AT21CS01 Silicon Errata

The AT21CS01 devices that you have received conform functionally to the current Device Data Sheet (DS20005857B), except for the anomalies described in this document.

FIGURE 1: EXAMPLE SCHEMATIC

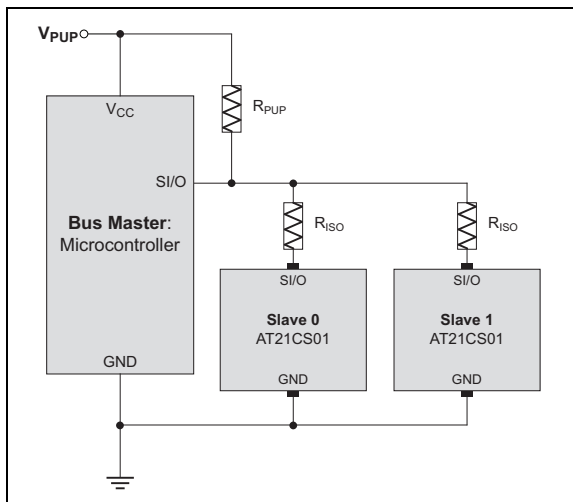
When multiple AT21CS01 devices are present on the single-wire bus, one or more devices may not reset properly after a device Reset or power-up event.

The device(s) that are not reset properly may remain active (driving SI/O low) following the device Reset or power-up event, resulting in corrupted communication.

Modify the firmware to force SI/O high during the entire t_{DACK} period following a device Reset or power-up event. Series resistors must be added to isolate the slave devices and reduce the output current. In addition, narrowing the Pull-Up Voltage V_{PUP} range may be necessary to meet timing and I/O level requirements during communication. [Figure 1](#) is an example Schematic with the isolation resistors R_{ISO} .
